# Central Falls High School

## 100% Construction Documents

Ai3 Project #2202.02

### **Addendum #3**

DRAWN BY: MS / CHR  
REVIEWED BY: CHR / KK  
SCALE: AS INDICATED DRAWING NUMBER:  
JOB NO.: 2202.02  
DATE: OCTOBER 13, 2023 **A7.73**

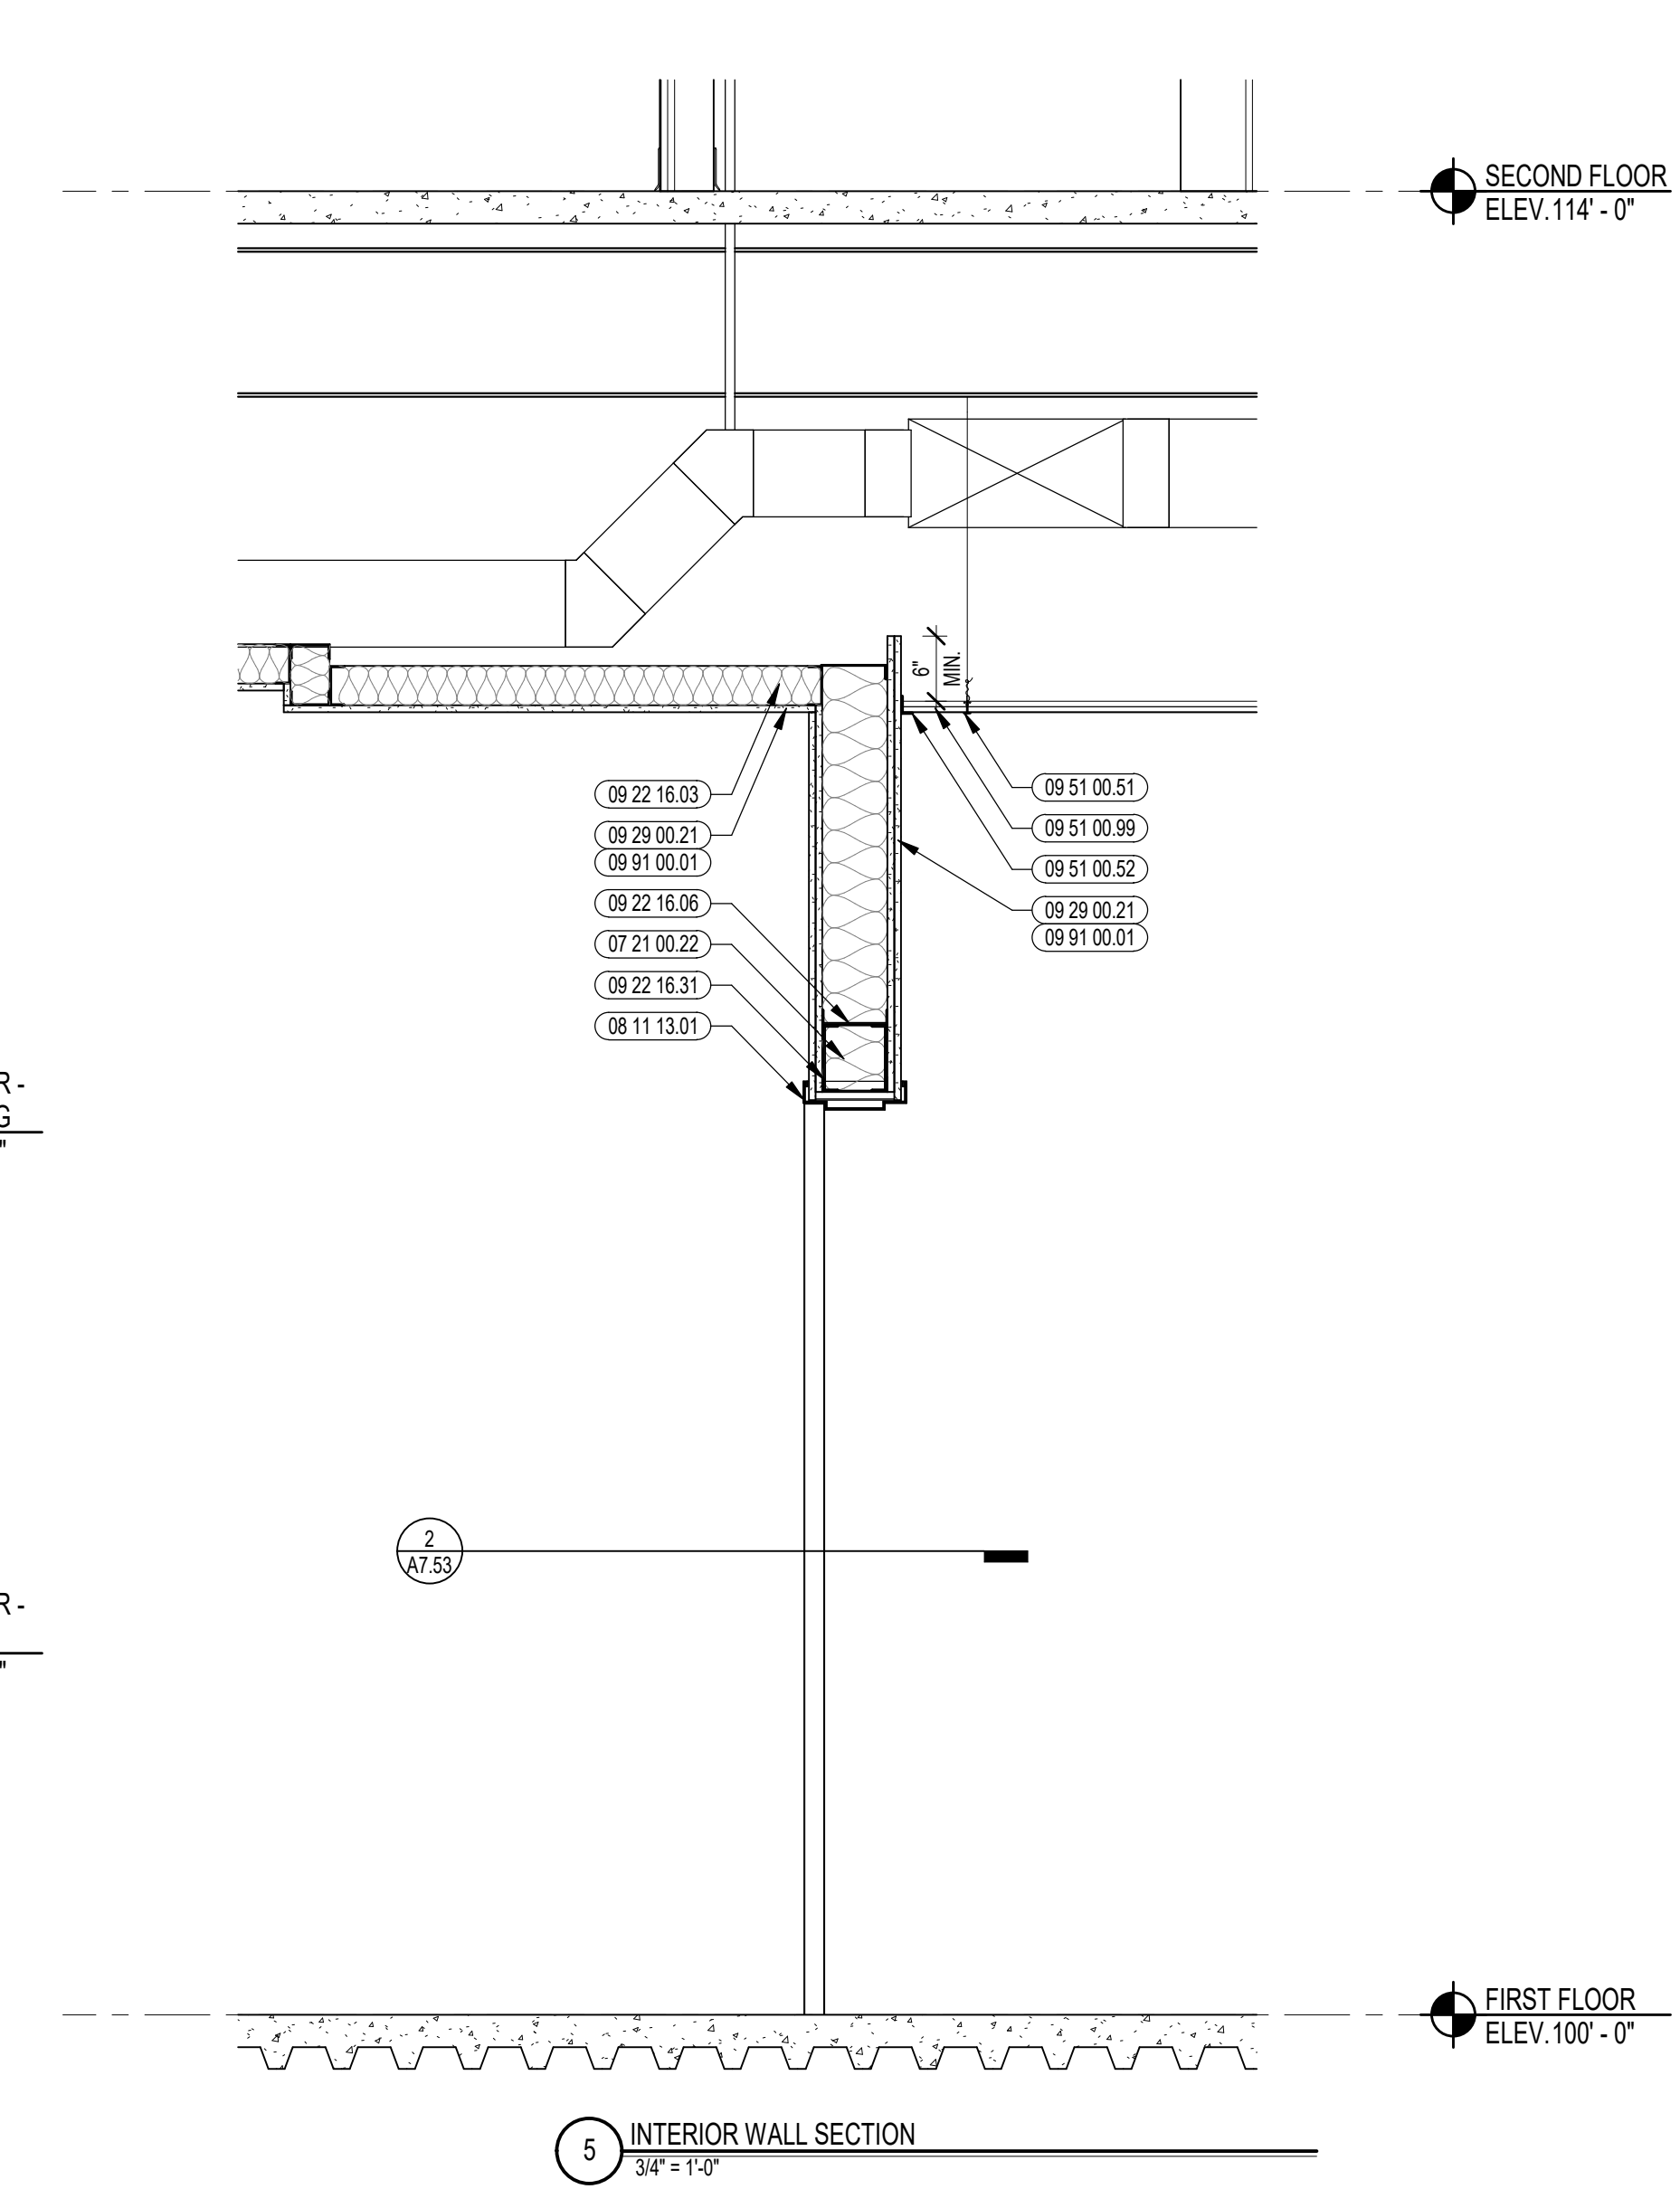
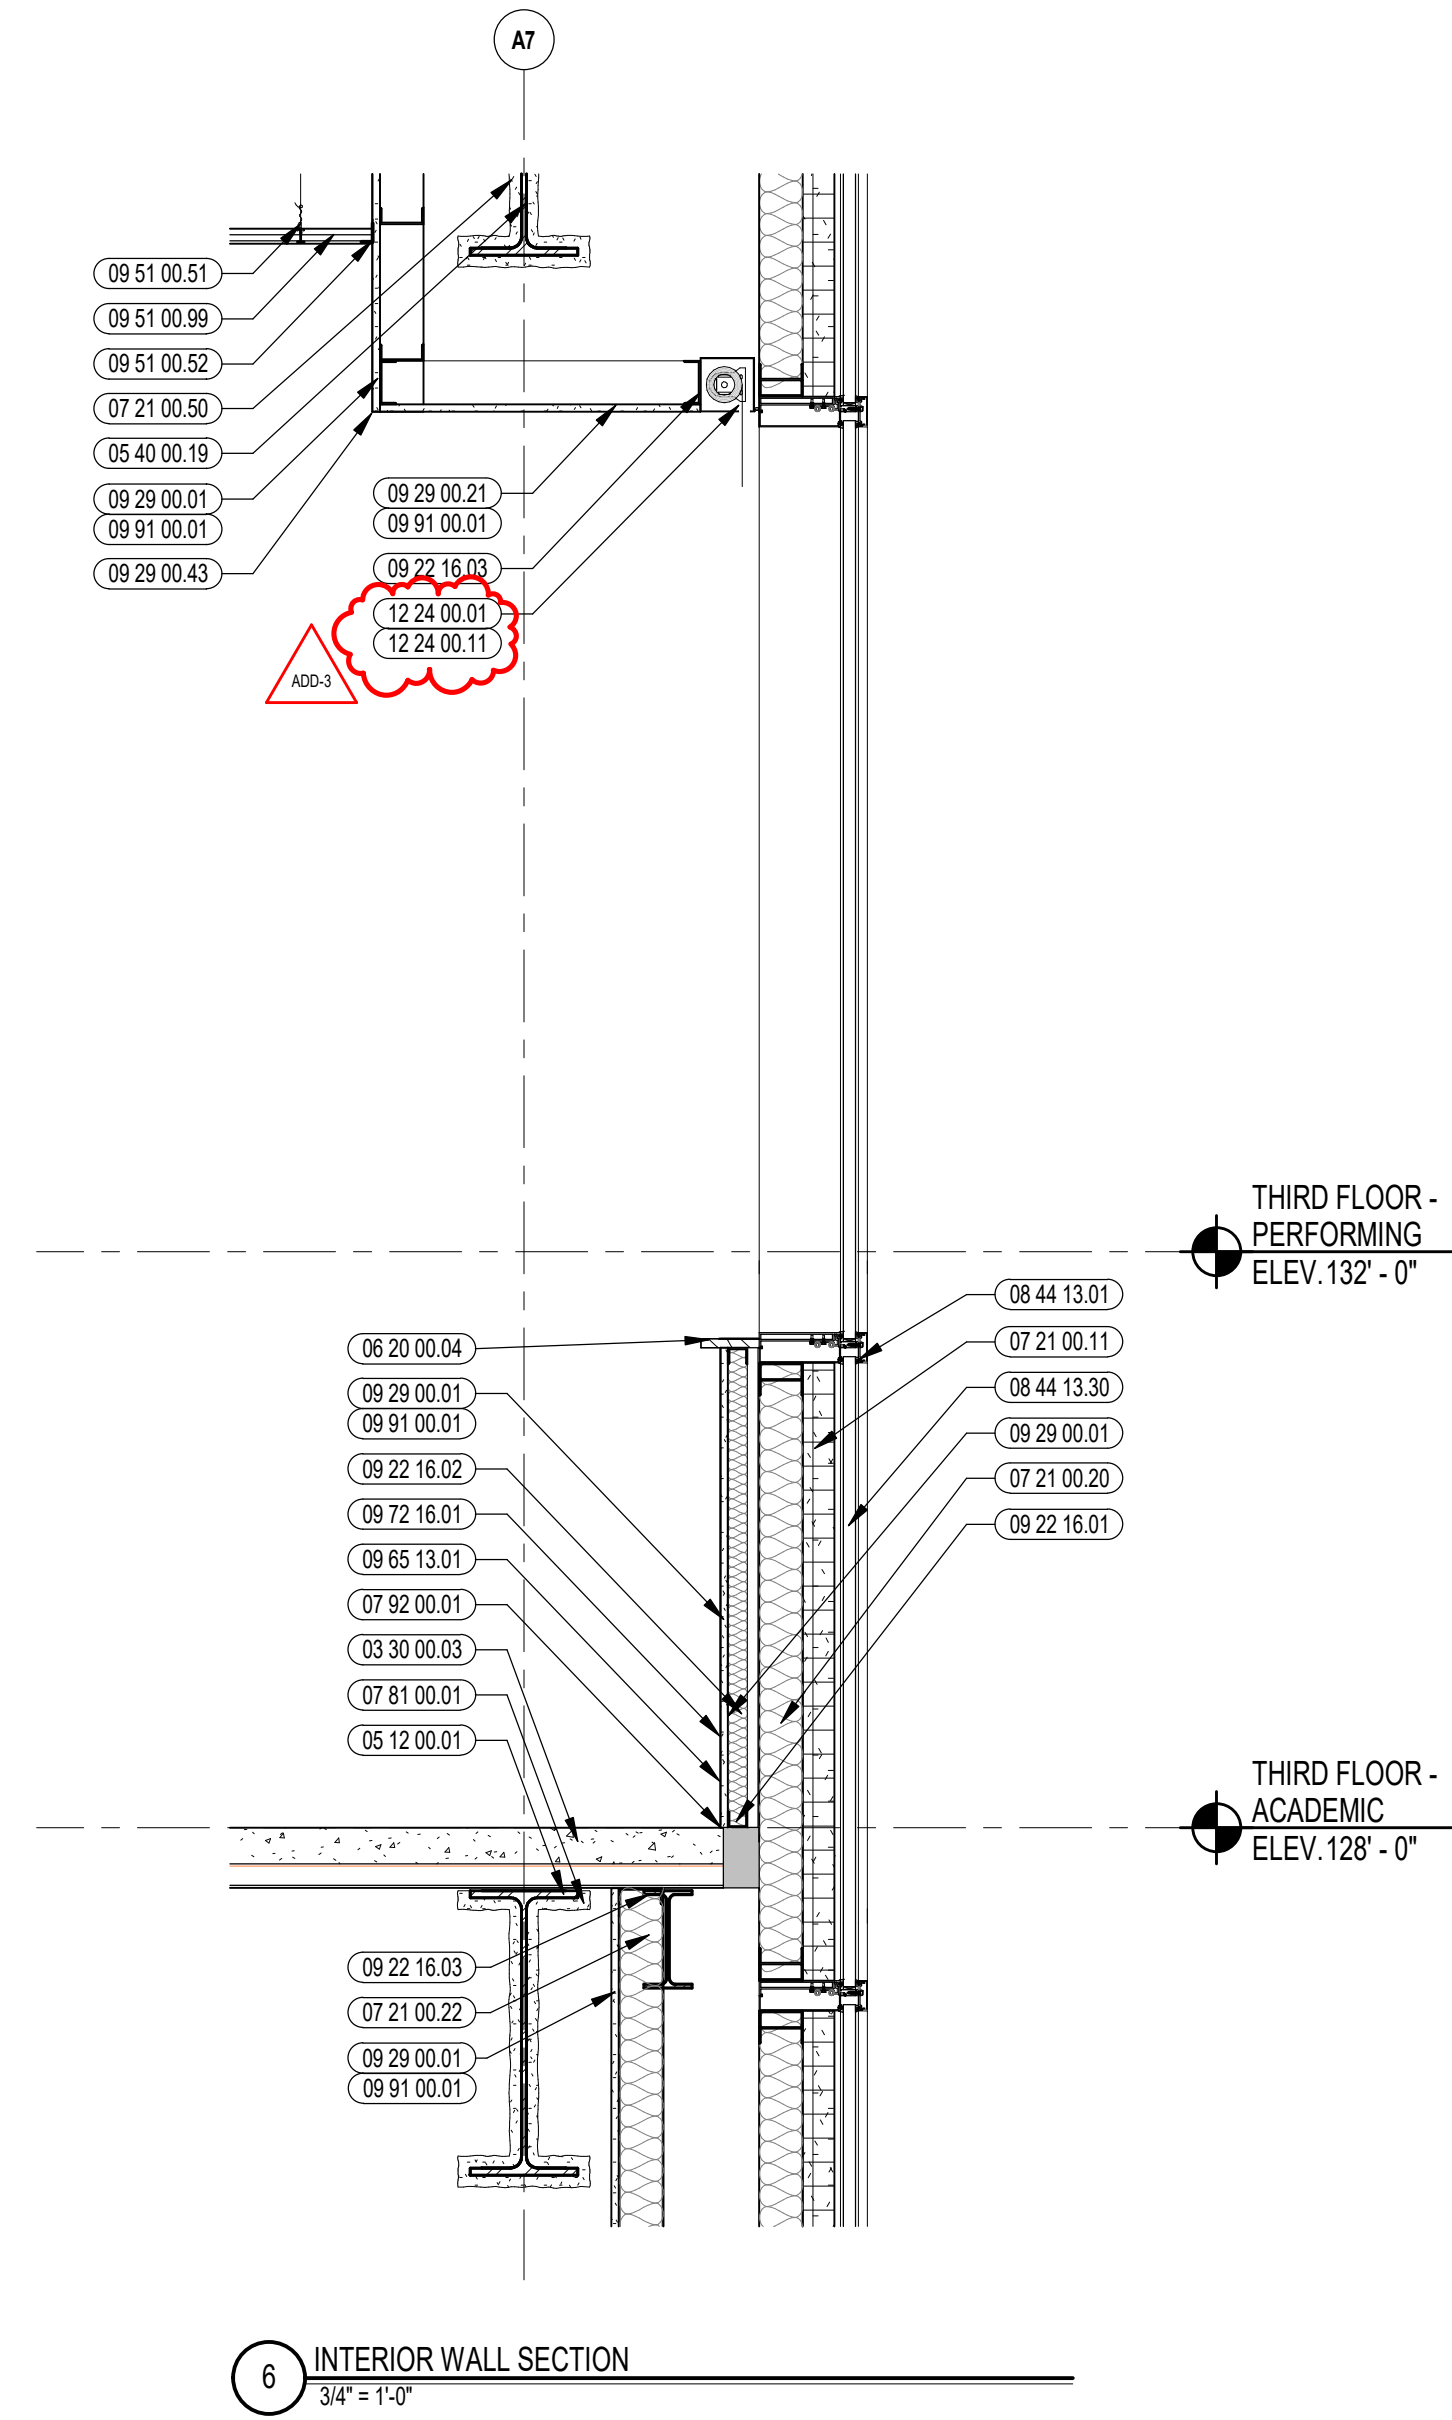
**ADD 3-002** **Bidder Question:** There doesn't seem to be drawings with Window Shade (Section 12 24 00) locations or any notes of the shades on the finished plans. The specs under part 2.1, they state there are roller shades manual, dual roller shades manual, blackout shades manual, and blackout shades motorized with locations for the blackout shades manual and blackout shade motorized. Where are these located? **Response:** Refer to opening details, interior wall sections, enlarged floor plans and elevations for keynoted shade

locations. See additional clarifications on A7.73, A9.25A, A10.20C and A10.41 in Addendum #3.
